V2 changes

Sol Eng – XV – V2

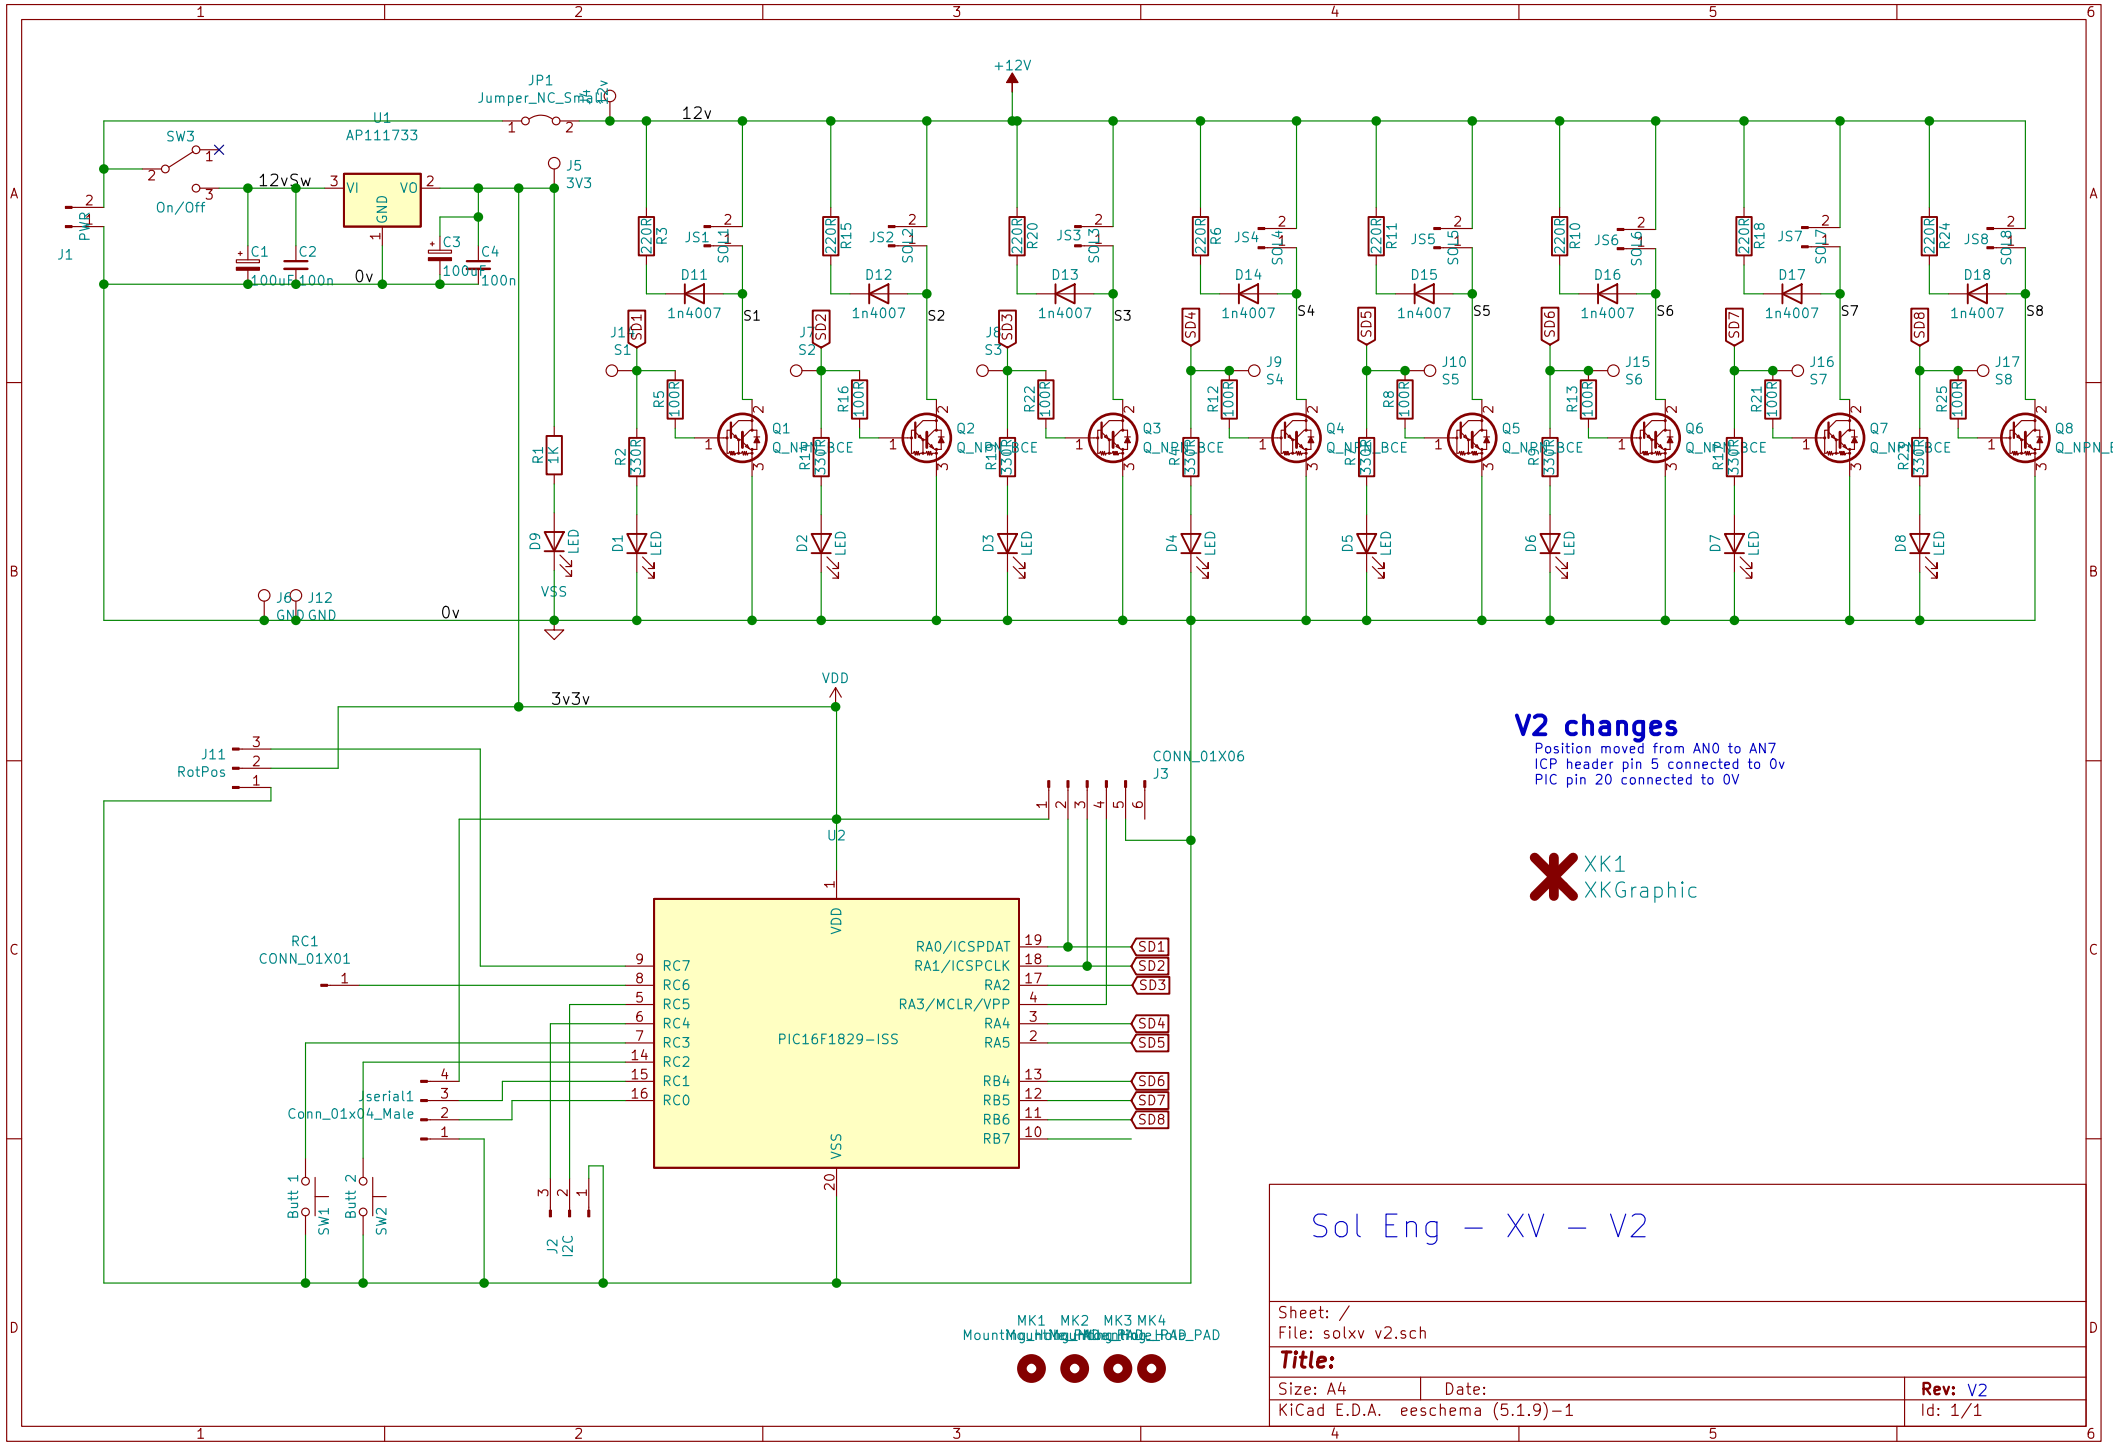
Position moved from AN0 to AN7
ICP header pin 5 connected to 0v
PIC pin 20 connected to 0V
